Amendment – XXVI dated 30.08.2024 to RFP documents for selection of bidder as Transmission Service Provider to establish Inter-State Transmission system for “Transmission System for Evacuation of power from potential renewable energy zone in Khavda area of Gujarat under Phase-V (8 GW): Part A” through tariff based competitive bidding process.

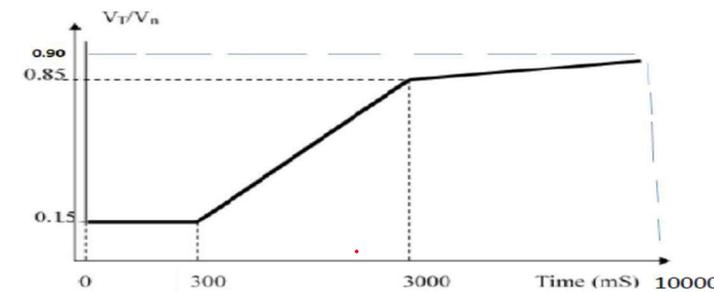
2.	6. System Performance RFP & TSA	... The rated power transmission capacity shall be defined and guaranteed at Rectifier DC Bus and rated transmission voltage shall be defined at the rectifier DC bus.	... The rated power transmission capacity shall be defined and guaranteed at Rectifier DC Bus and rated transmission voltage shall be defined at the rectifier DC bus. <u>In the calculation of the power transmission capability, the most unfavourable combination of control and measurement tolerances shall be considered and without redundant cooling and thyristors. All components of the transmission system shall be rated to meet the requirements</u>

Sl No.	Clause No.	Existing Provision	New/Revised Provision
			<p><u>given in this section and other requirements specified elsewhere under these Specifications.</u></p> <p><u>HVDC system performance and rating requirements for high voltage equipment and other critical equipment shall be determined taking into account the extreme values of environmental and AC and DC system parameters as applicable for performance/ rating requirements given under these Specifications and manufacturing and measuring tolerances.</u></p>
